SUNDRY NOTICES AND REPORTS ON WELLS
Do not use this form for proposals to drill or to re-enter an abandoned well. Use form 3160-3 (APD) for such proposals.

8. Well Name and No.
SAN JUAN 28-7 116

Conoco proposes to plug and abandon this well using the attached procedure. Also attached are the current and proposed wellbore schematics.

Re: Permanent Abandonment

Proposed P&A

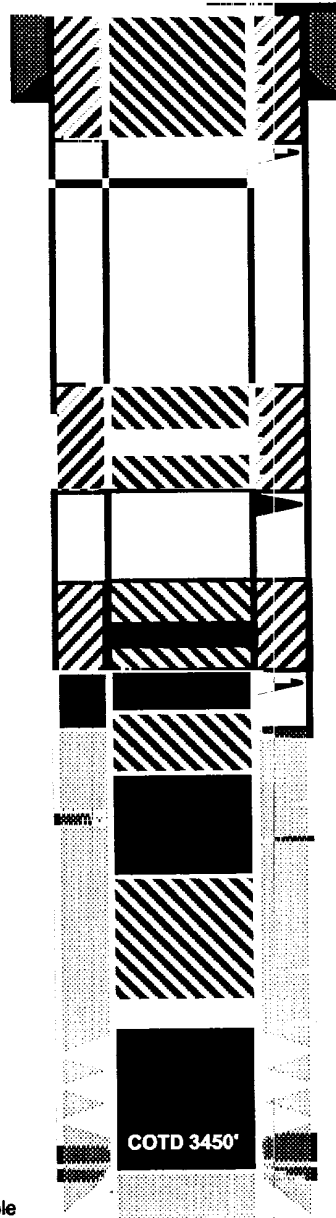
a) Bring the top of the Pictured Cliffs/Fruitland plug to 3005'.

b) Place the Nacimiento plug from 1584' - 1484' inside and outside the 5 ½" casing.
